# Comal County Environmental Health OSSF Inspection Sheet

## Permit of Authorization to Construct an On-Site Sewage Facility Permit Valid For One Year From Date Issued

**REVISED**

RE: 1212 Blueridge Dr(permit #116119) - Water line variance request

GARRETT LEGACY VENTURES LLC  
1212 BLUERIDGE DR  
CANYON LAKE, TX. 78133  
CANYON LAKE HILLS  
UNIT 1, LOT 147  
COMAL COUNTY / 0.1148 ACRES

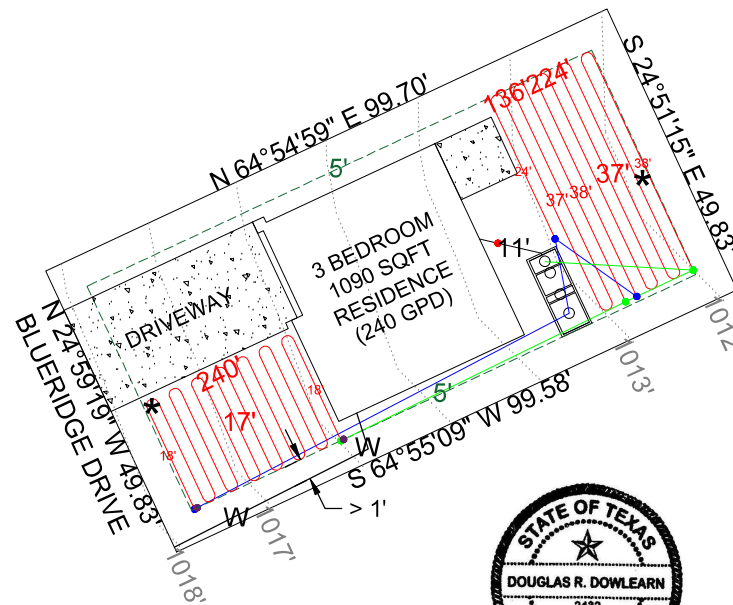
I am requesting a variance for a water line to be placed within 10 feet of a drain field . This variance is requested due to limited space. Equivalent protection will be maintained by sleeving the water line with SCH 40 PVC pipe where it is within 10' of the drain field. The water line will be greater than 1' away from the drainfield; therefore is out of the absorption area.

- TANK WILL BE WATER TIGHT AND MANUFACTURED ACCORDING TO ASTM DESIGNATION: C 1227.
- INSTALL 1" VACUUM BREAKERS AT HIGHEST POINTS ON SUPPLY AND FLUSH LINES.
- WATER LINE WILL BE SLEEVED IN SCH 40 PIPE WHERE IT CROSSES THE 1" SCH 40 SUPPLY AND FLUSH LINES AND 10' BEYOND. SLEEAVING THE WATER LINE WILL PROVIDE EQUIVALENT PROTECTION TO THE SETBACK REQUIREMENTS IN TAC 290 CONCERNING WATER LINES.
- WATER LINE WILL BE SLEEVED WHERE IT IS WITHIN 10' OF THE DRIP FIELD. THIS WILL PROVIDE EQUIVALENT PROTECTION FOR THE SETBACK REQUIREMENTS OF TAC 290 - SEE VARIANCE REQUEST.

- WATER LINE WILL MAINTAIN GREATER THAN 10' SEPARATION FROM ANY PART OF THE OSSF. THIS WILL PROVIDE EQUIVALENT PROTECTION FOR THE SETBACK REQUIREMENTS OF TAC 290.
- CLEANOUT WITHIN 3' OF STRUCTURE.
- PVC CONNECTING THE STRUCTURE TO THE TANK MUST HAVE AT MINIMUM 1/8" FALL PER 1'.
- USE 3" OR 4" SCH 40 SEWER PIPE TO CONNECT STRUCTURE TO TANK.
- TANK TO BE > 5' FROM STRUCTURES. THIS WILL PROVIDE EQUIVALENT PROTECTION FOR THE SETBACK REQUIREMENTS OF TAC 285.

MODEL 600NC3T  
 600 G.P.D. TREATMENT SYSTEM

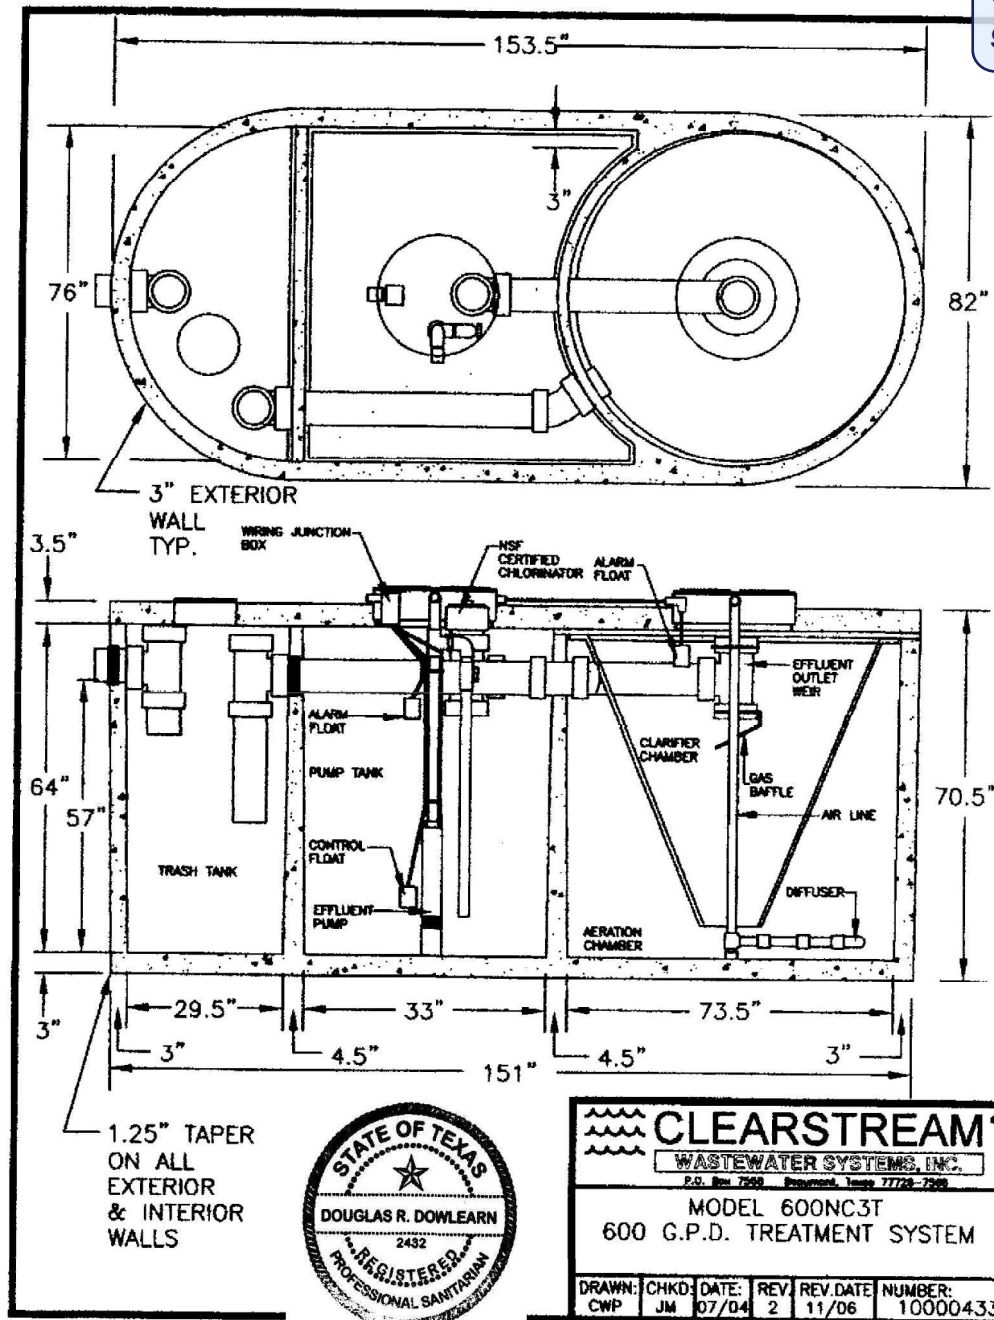
A 3” or 4” PVC pipe will discharge from the structure to a Clearstream 600 GPD ATU, model 600NC3T equipped with a 20 gpm submersible pump. The pump is activated by a time controller allowing the distribution 8 times per day with a 10 minute run time per dose, with float switches set to pump 240 gallons per day. A high level audible and visual alarm will activate should the pump fail. Distribution from the pump is through a self flushing 100 micron, 140 mesh disc filter, then through a 1” SCH-40 manifold to a 600 L.F. drip tubing field, with drip lines set approximately two feet apart with 0.61 gph emitters set every two feet, as per the attached schematic. A threaded union will be installed in the pump tank on the supply manifold to the drip field, and a pressure regulator will be installed on the supply manifold to maintain a pressure of 30 psi. A 1” SCH-40 return line is installed to periodically flush the system by cycling a 1” ball valve. Solids caught in the spin filter are flushed each cycle back to the pre-treatment tank. Vacuum breakers installed at the highest point on each manifold will prevent siphoning of effluent from higher to lower parts of the field. The placement of the drip tubing will be on soil that has been scarified, and enough class II soil will be added so that there is 12” of soil under the drip tubing. The tubing will be covered with 6” of Class II soil.
